SERVICE BULLETIN

N° **139-729**

ATA 28 – FUEL PORT MODIFICATION

AW139 helicopters from S/N 41801 to S/N 41804.

Figure 7

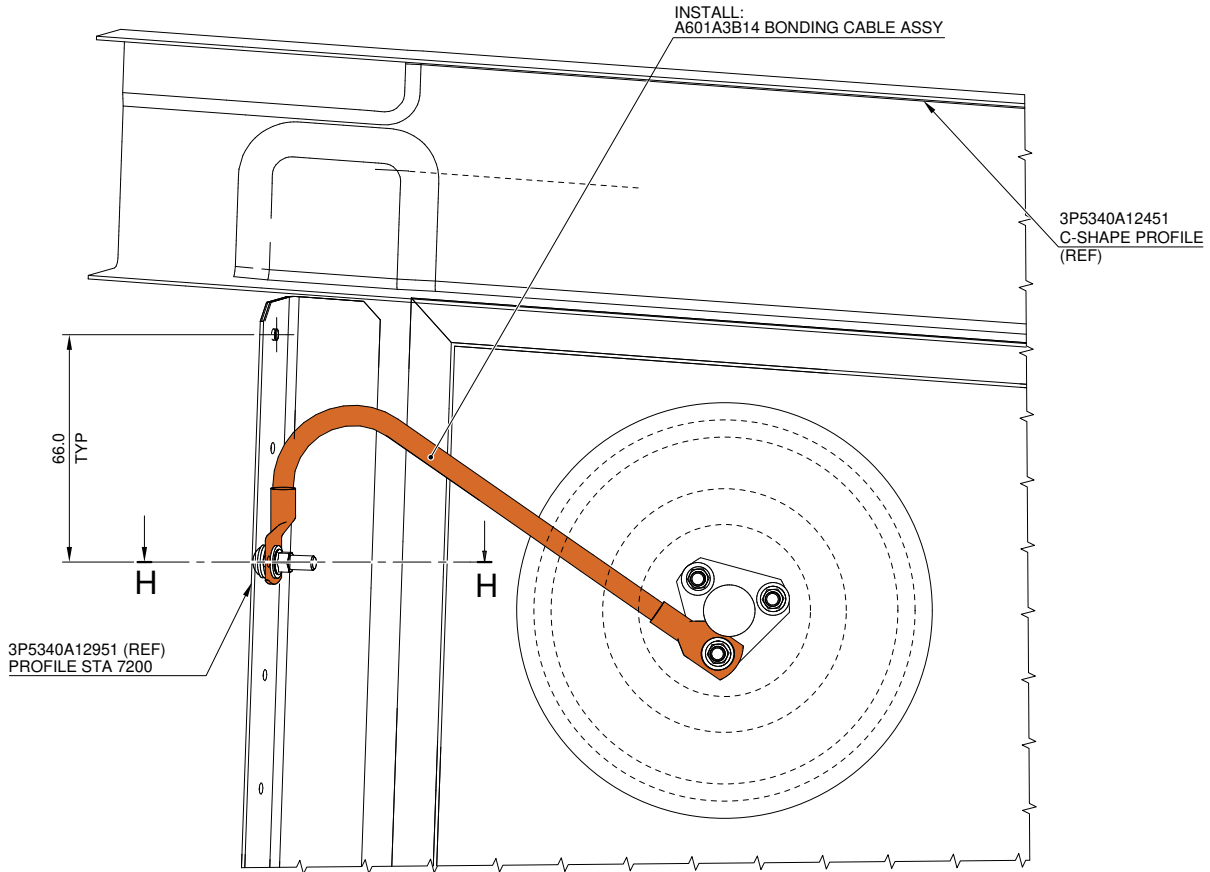
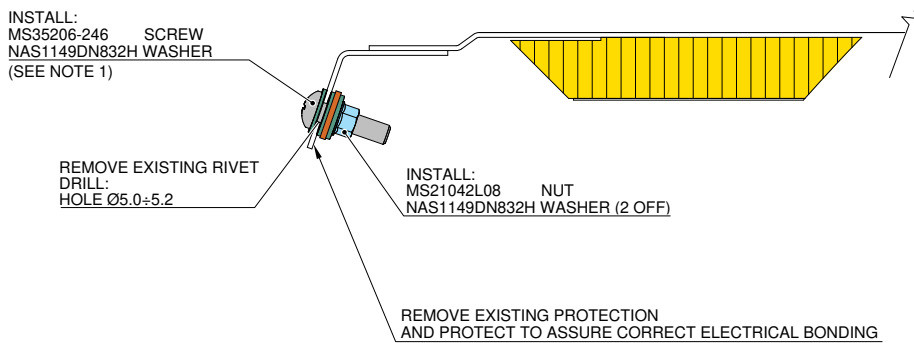
- 2.6 With reference to Figure 6 Section E-E, install grounding connector P/N A605A01 by means of n°2 screws P/N MS35206-246, n°4 washers P/N NAS1149DN832H and n°2 nuts P/N MS21042L08.
- 2.7 With reference to Figure 7 Section H-H, remove existing rivets and drill a hole Ø 5.0÷5.2 on the profile STA 7200 P/N 3P5340A12951.
- 2.8 In accordance with AMP DM 39-A-20-10-01-00A-259A-A and with reference to Figure 7 Section H-H, prepare the indicated surfaces on the profile STA 7200 to assure the correct electrical bonding
- 2.9 With reference to Figure 6 Section G-G and Figure 7 Section H-H, install the bonding cable assy P/N A601A3B14 by means of n°2 screws P/N MS35206-246, n°6 washers P/N NAS1149DN832H and n°2 nuts P/N MS21042L08.

Figure 8

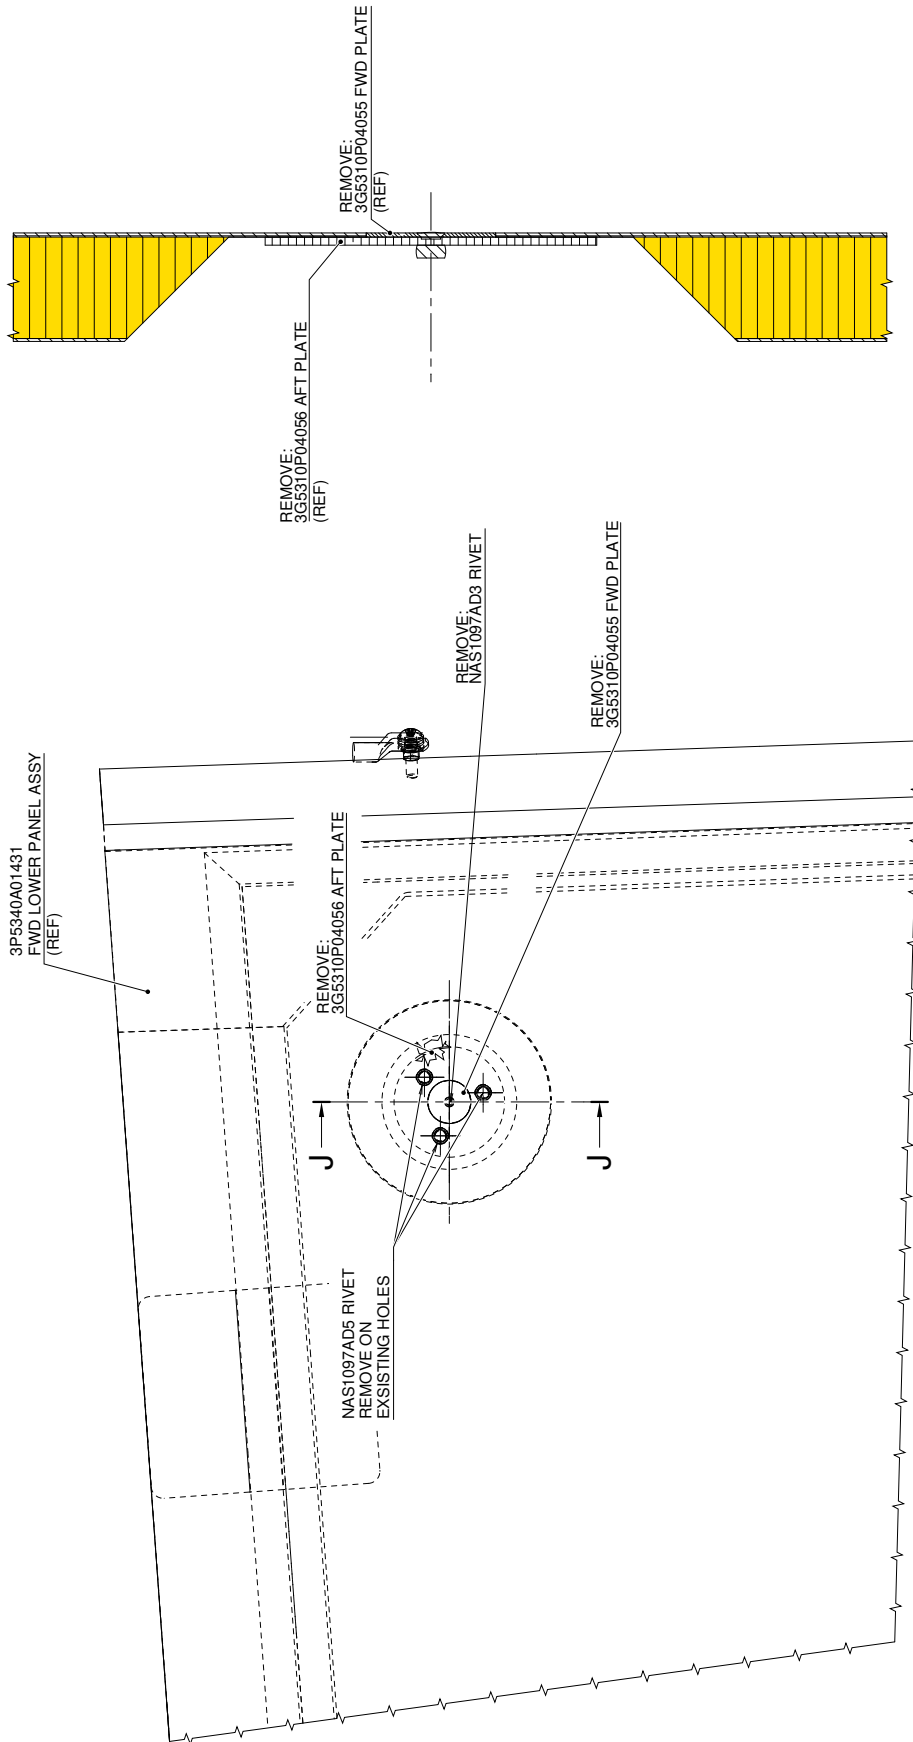
- 2.4 With reference to Figure 8, remove the aft plate P/N 3G5310P04056 and the FWD plate P/N 3G5310P04055 and related fixing hardware from the FWD lower panel assy P/N 3P5340A01431.

Figure 10

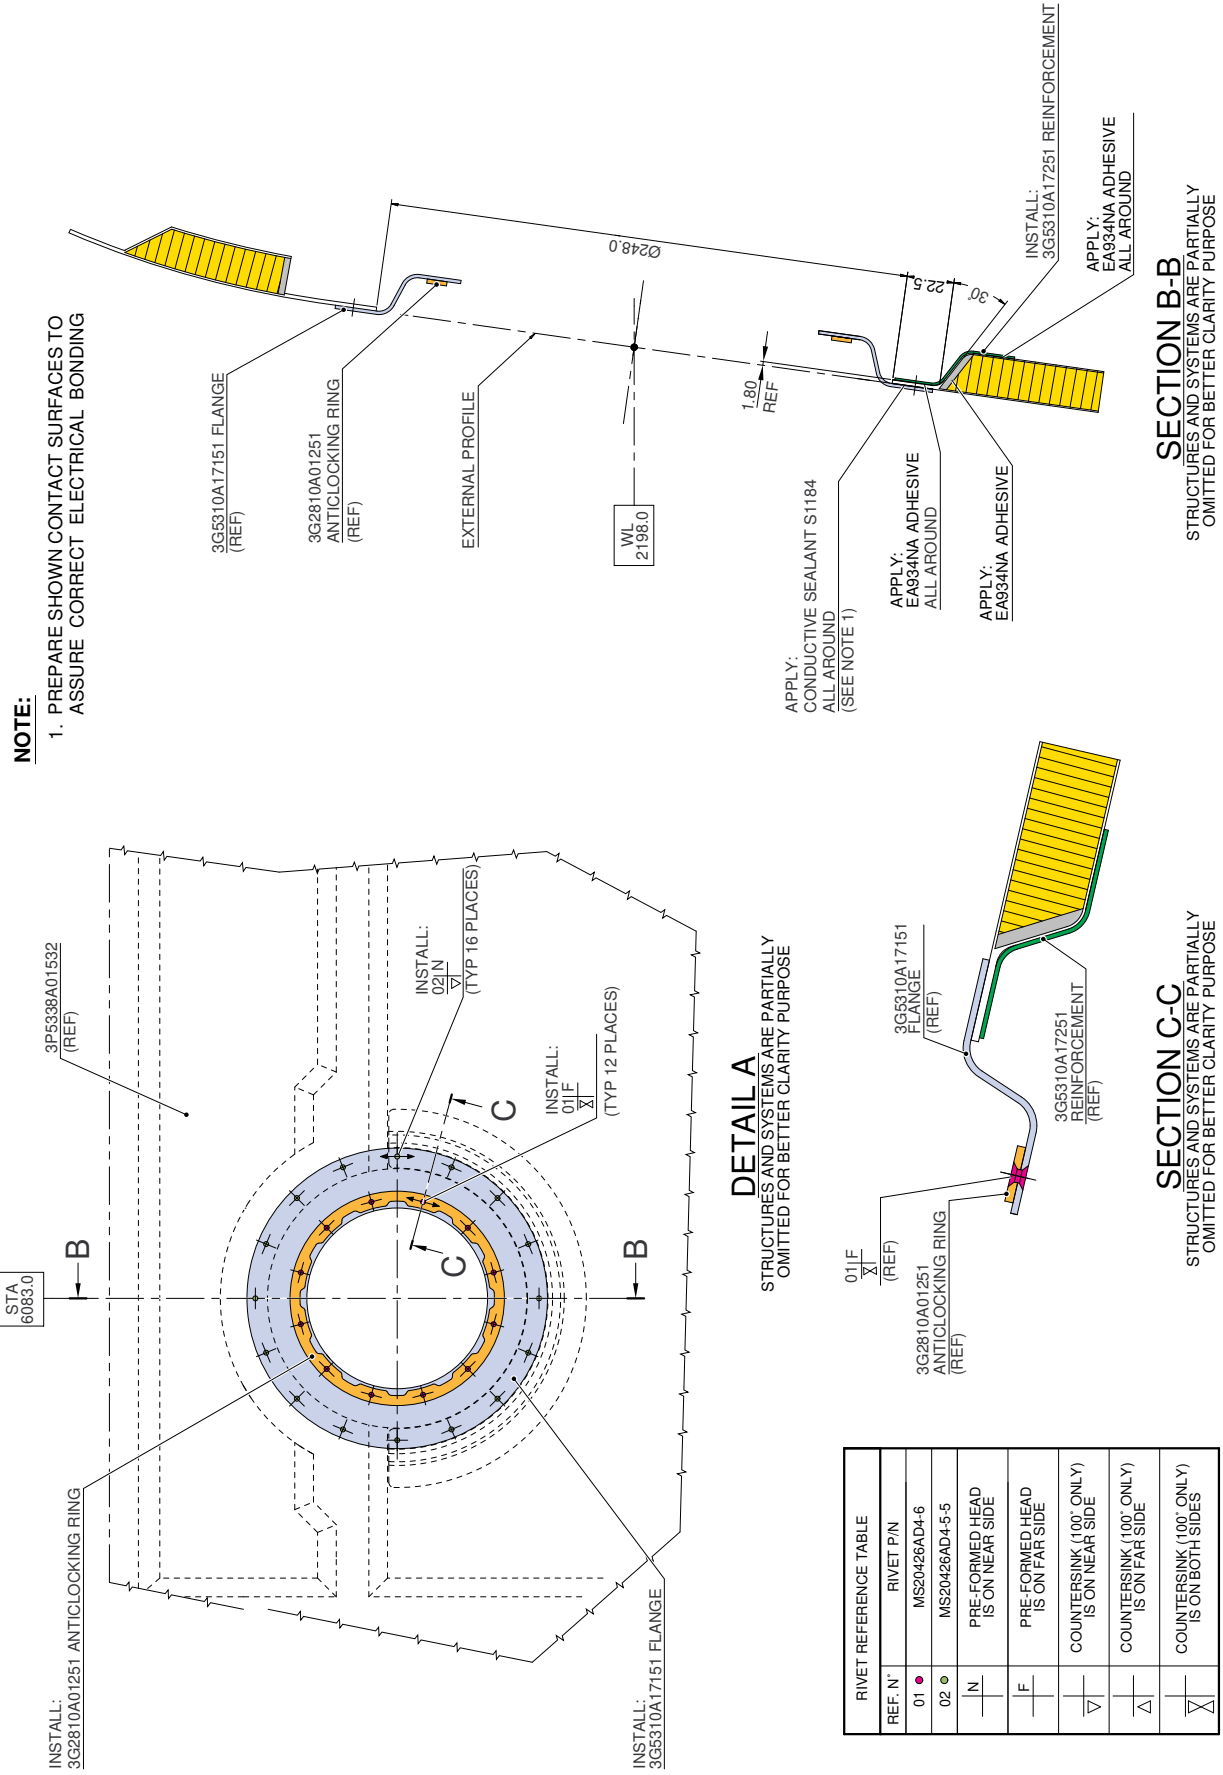
- fiberglass 20644 1200 by means of adhesive EA 956 AERO (C193).
- 3.6 With reference to Figure 10 Section B-B, install the reinforcement P/N°3G5310A17251 by means of adhesive EA9309.3NA (C021).
 - 3.7 With reference to Figure 15 Section P-P and Section R-R, install collar shim P/N°3G5338A27051 as required.
 - 3.8 With reference to Figure 10 Detail A, install the anticlocking ring P/N 3G2810A01251 by means of n°12 rivets P/N°MS20426AD4-6 on the flange P/N°3G5310A17151.
 - 3.9 In accordance with AMP DM 39-A-20-10-01-00A-259A-A and with reference to Figure 10 Section B-B, prepare the indicated contact surfaces to assure the correct electrical bonding.
 - 3.10 With reference to Figure 10 Detail A and Section B-B, install the flange P/N 3G5310A17151 by means of n°16 rivets P/N° MS20426AD4-5-5 on the panel P/N 3P5338A01532. Use conductive sealant S1184 all around.

Figure 11

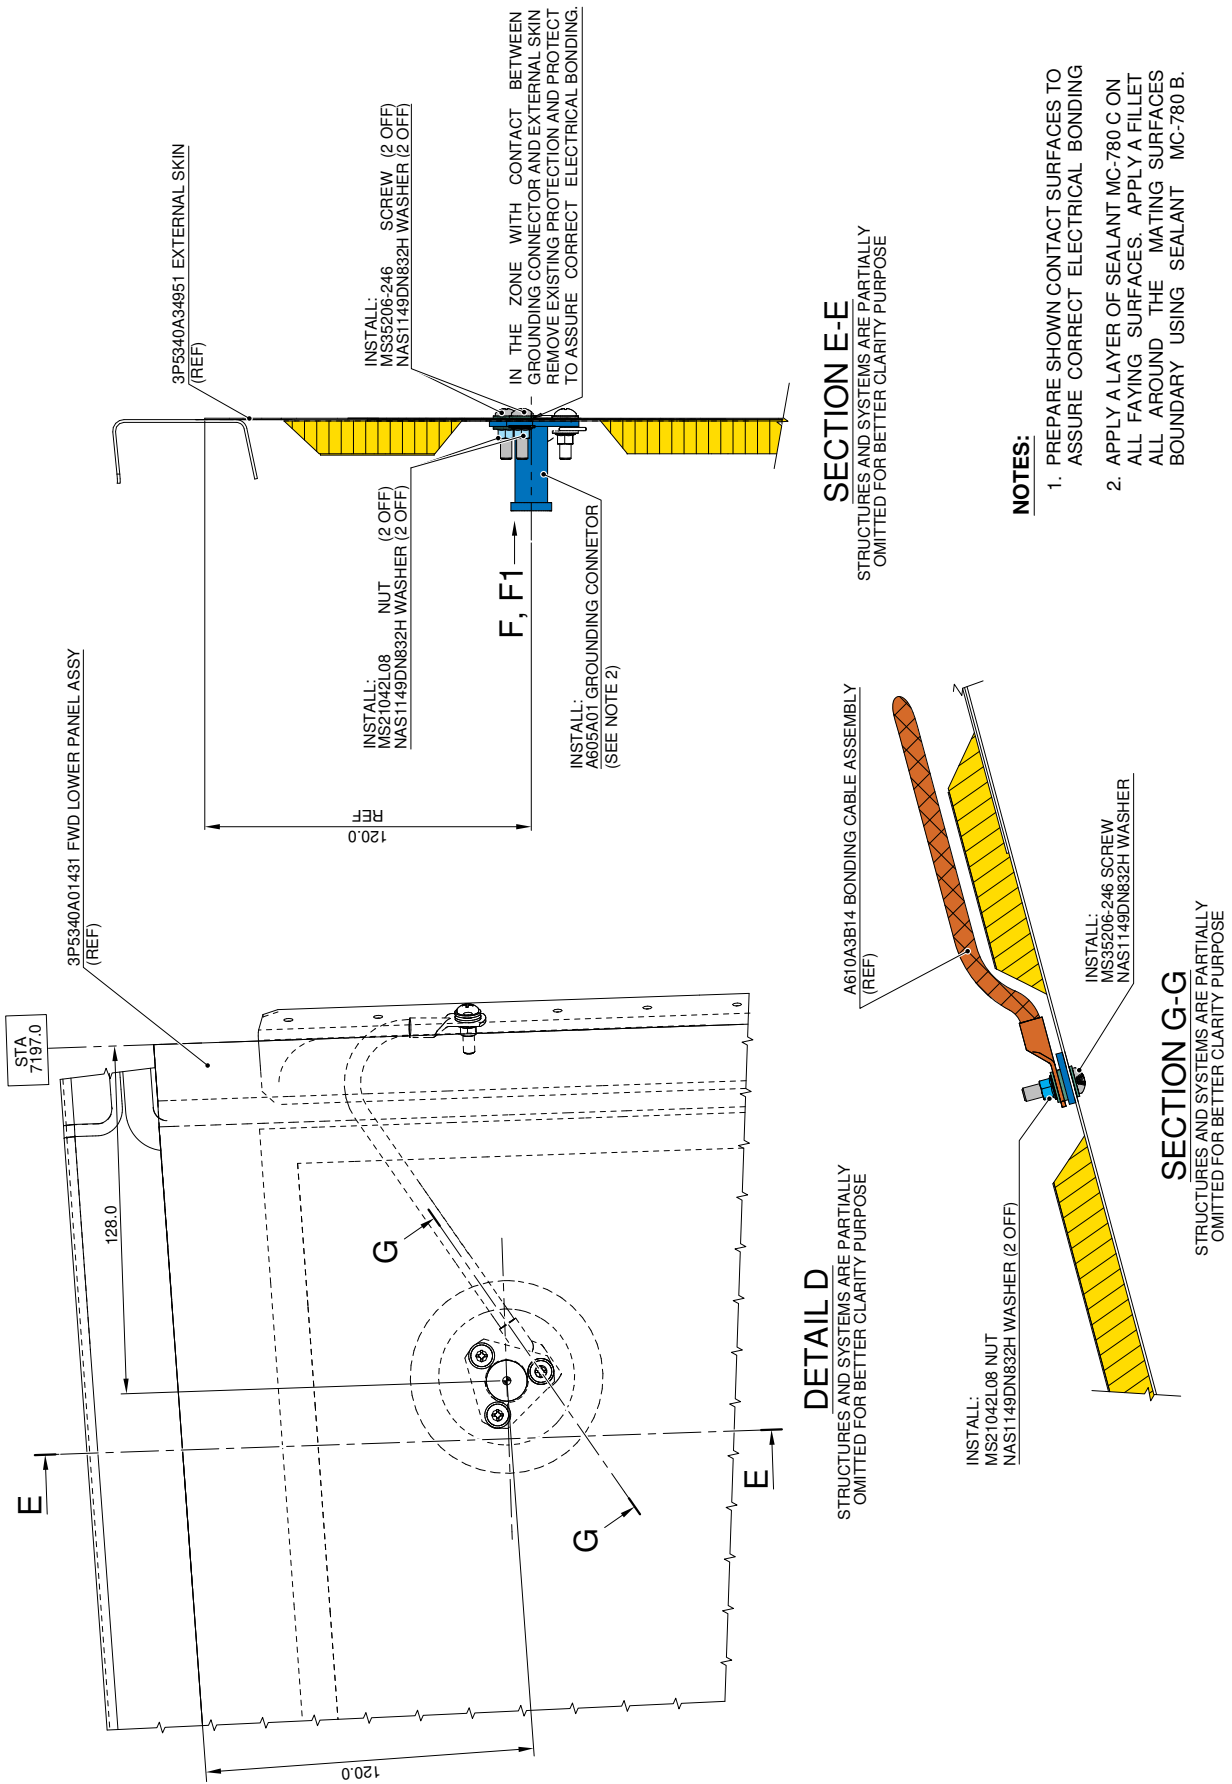
- 3.11 With reference to Figure 11 Detail D and Figure 13, remove honeycomb core Ø 50.0 from the internal side of the FWD lower panel assy P/N 3P5340A01431 as indicated.

- 3.17 In accordance with AMP DM 39-A-20-10-01-00A-259A-A and with reference to Figure 11 Section E-E, prepare the indicated contact surfaces on the external skin P/N 3P5340A34951 to assure the correct electrical bonding.

- 3.18 With reference to Figure 11 Section E-E, install grounding connector P/N A605A01 by means of n°2 screws P/N MS35206-246, n°4 washers P/N NAS1149DN832H and n°2 nuts P/N MS21042L08.
- 3.19 With reference to Figure 12 Section H-H, remove existing rivets and drill a hole \varnothing 5.0÷5.2 on the profile STA 7200 P/N 3P5340A12951.
- 3.20 In accordance with AMP DM 39-A-20-10-01-00A-259A-A and with reference to Figure 12 Section H-H, prepare the indicated surfaces on the profile STA 7200 to assure the correct electrical bonding
- 3.21 With reference to Figure 11 Section G-G and Figure 12 Section H-H, install the bonding cable assy P/N A601A3B14 by means of n°2 screws P/N MS35206-246, n°6 washers P/N NAS1149DN832H and n°2 nuts P/N MS21042L08.
4. With reference to Figure 16, perform the cover plug fuel tank CCRR ISO45 installation P/N 3G5338A26711 as described in the following procedure:

Figure 13

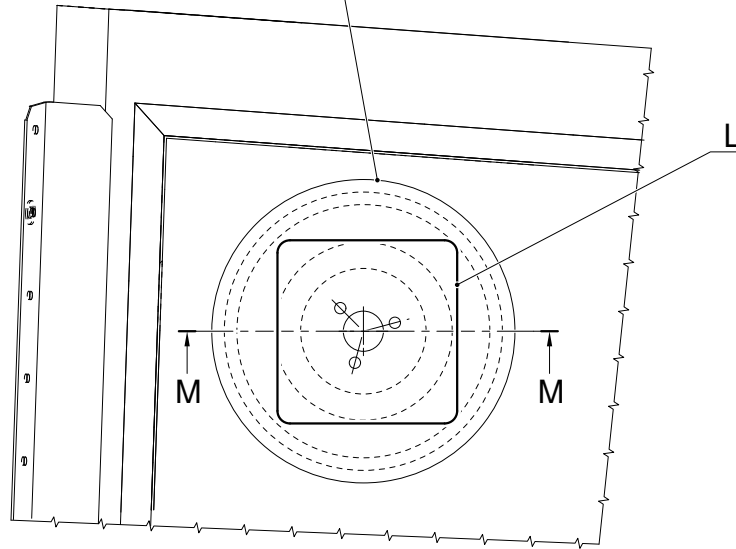
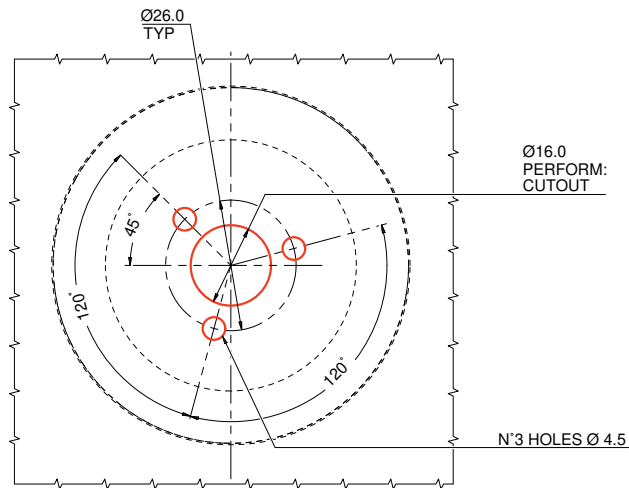
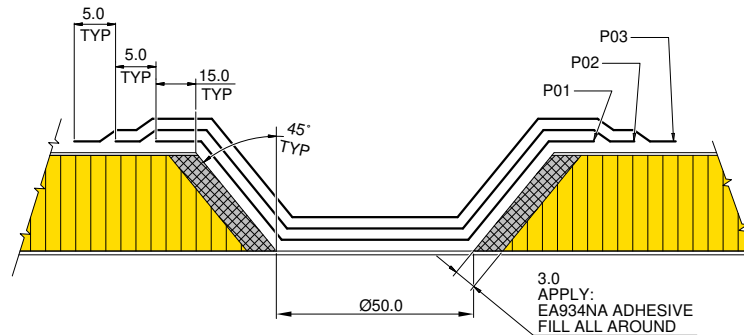
Carefully rework where indicated and remove honeycomb core in localised areas ensuring no damage to external skin (Ref. Figure 13).

- 3.12 With reference to Figure 13 Schematic Section M-M, seal honeycomb edge by means of adhesive EA934NA (C057).
- 3.13 Prepare a mixture of 23 parts by weight of hardener B5173 with 100 parts by weight of epoxy resin Araldit LY5138-2.

- 3.14 With reference to Figure 13 Schematic Section M-M, perform the indicated reparation by means of n°3 plies of fiberglass fabric 20749 1200 (C931) soaked with the previously prepared compound.

- 3.15 With reference to Figure 13 Detail L, perform the indicated cut-out Ø 16.0 through the panel.
- 3.16 With reference to Figure 13 Detail L, drill n°3 holes Ø 4.5 through the panel.

Figure 15

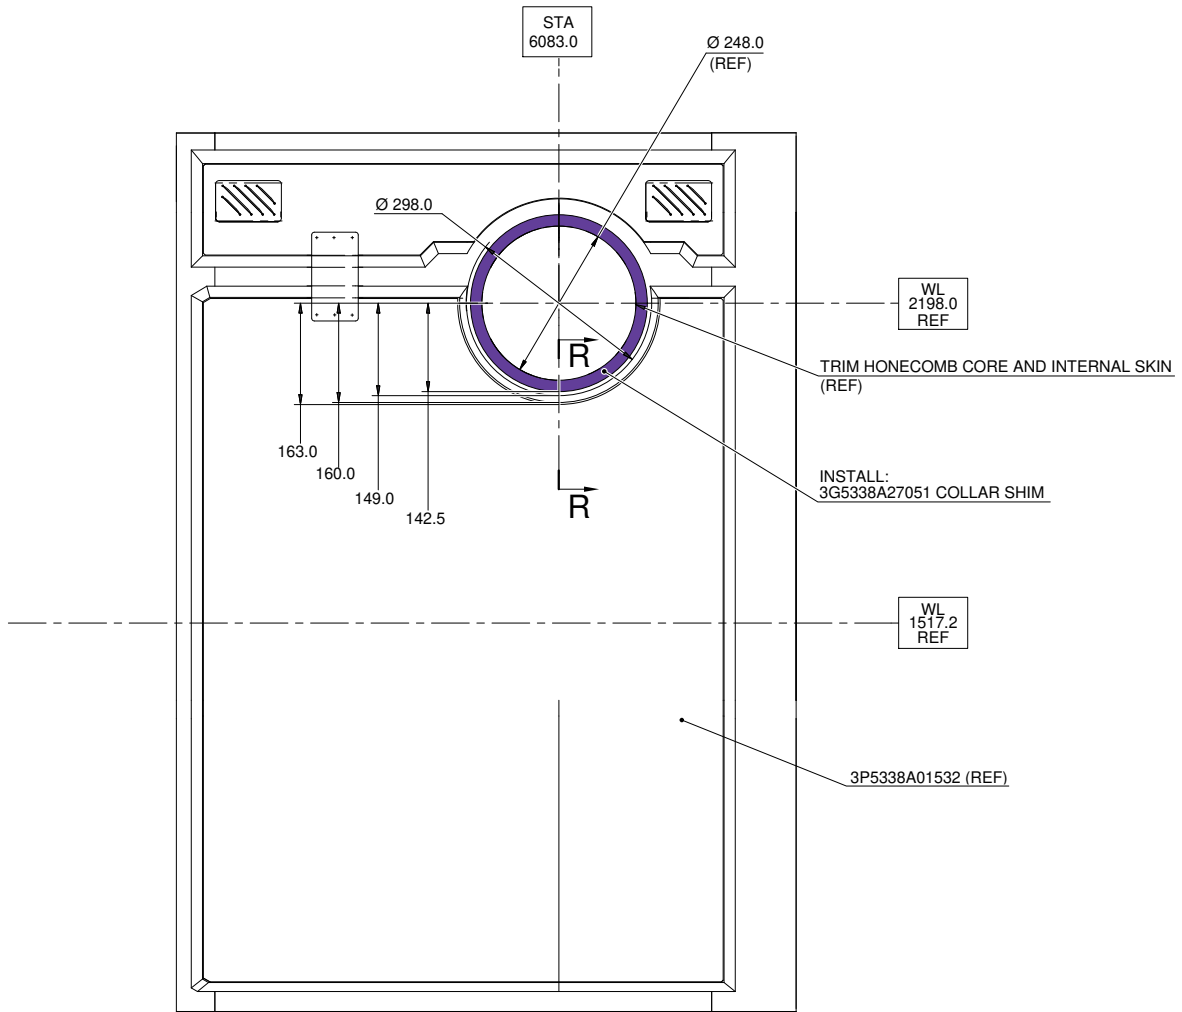
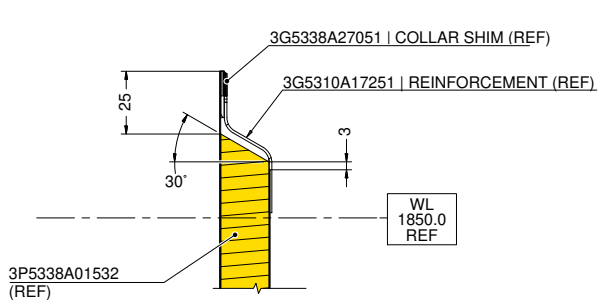
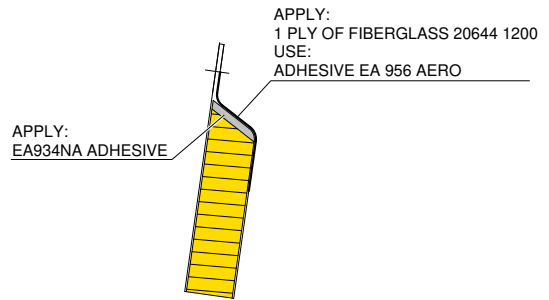
Carefully rework where indicated and remove honeycomb core in localised areas ensuring no damage to external skin (Ref. Figure 15).

- 3.2 With reference to Figure 15 Section P-P and Section R-R, remove honeycomb core Ø 298.0 from the internal side of the panel P/N 3P5338A01532 in correspondence of the previously performed cut-out.
- 3.3 With reference to Figure 15 Section P-P and Section R-R, trim honeycomb core and internal skin of the panel P/N 3P5338A01532.
- 3.4 With reference to Figure 15 Schematic View, seal honeycomb edge by means of adhesive EA934NA (C057).
- 3.5 With reference to Figure 15 Schematic View, apply on the cut out edges a ply of
